Service Bulletin

No. : MZ09-136

Model: SR6004, SR5004

Subject: The unit might be turning on the "protection-mode (Standby LED is flashing at high speed)".

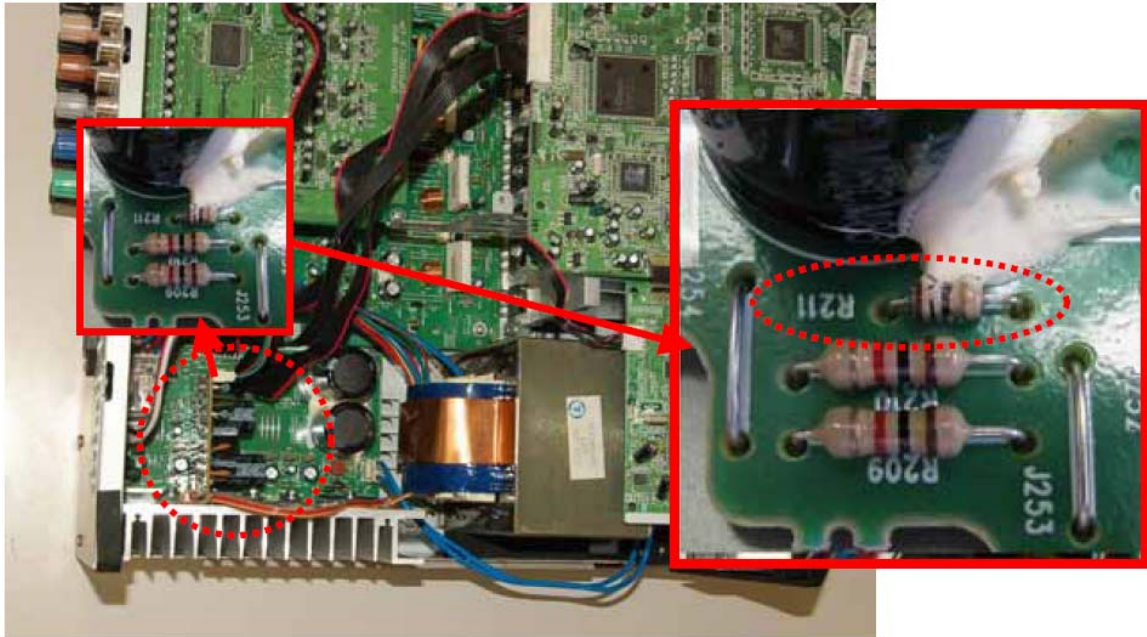
Symptom: Standby LED flashes at high speed.

Cause: If customer connects the specific HDMI cable or extra HDMI repeater to the unit, current of grounding circuit will be increased, and the grounding level is not stable. Therefore balance of voltage of power supply (+/-12Volts) is not stable, and then the unit might be turning on the "protection-mode".

Solution: Please short the both end of R211 (10 ohms).

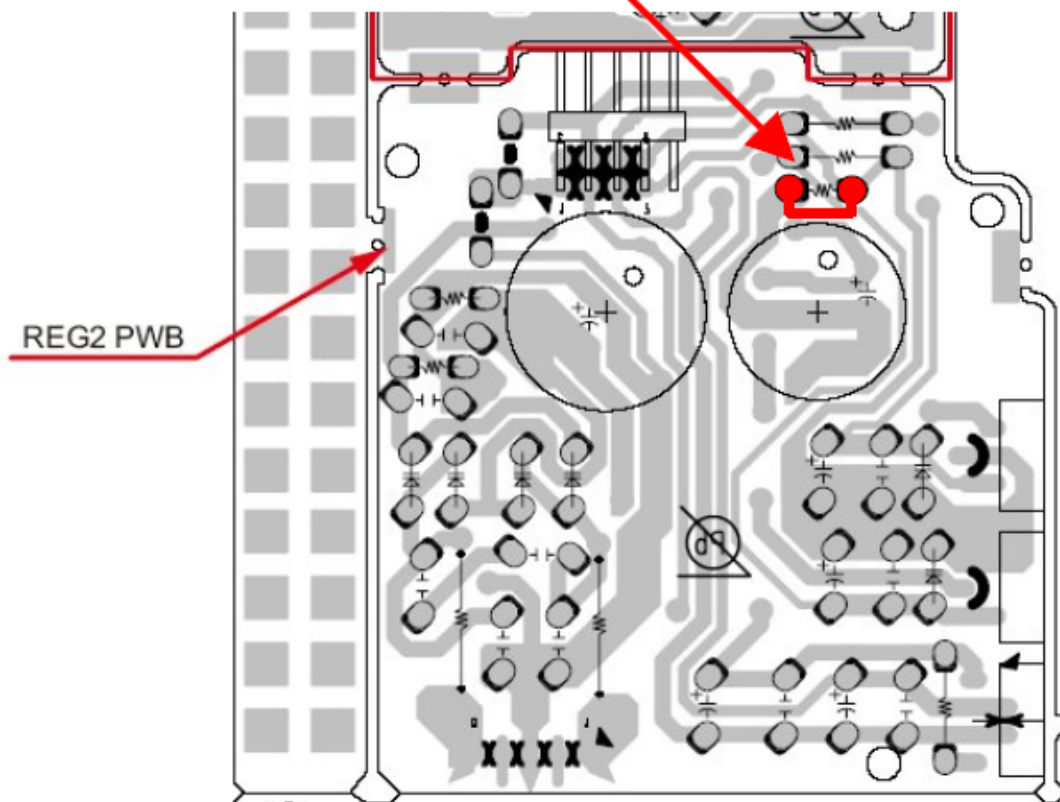
- 1) Remove the "REG PWB (REG2 PWB)" ASSY from the unit.

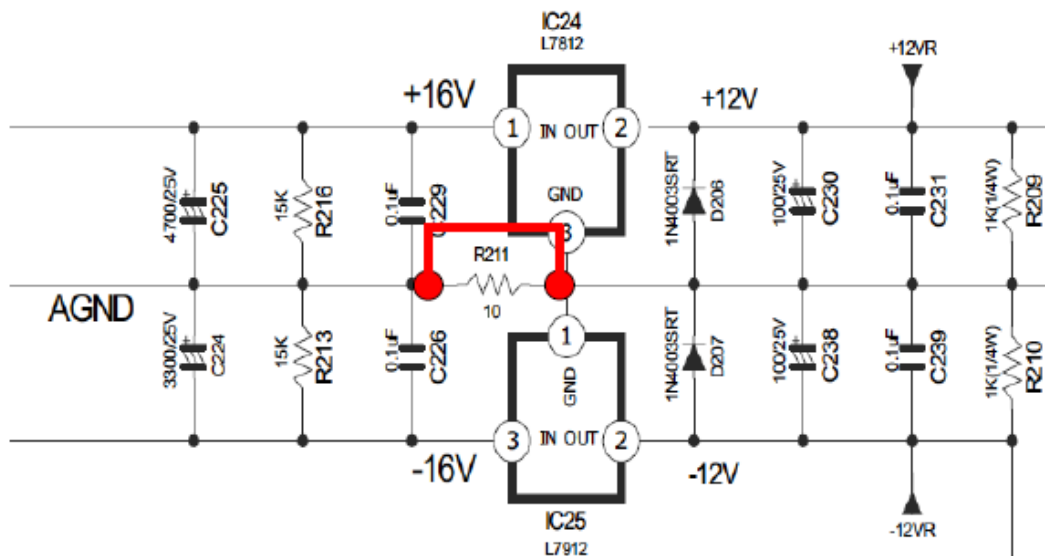
- 2) Short between both lands of pattern side of the R211 by thin copper wire.
(Please do not cut the R211 10 ohms.)
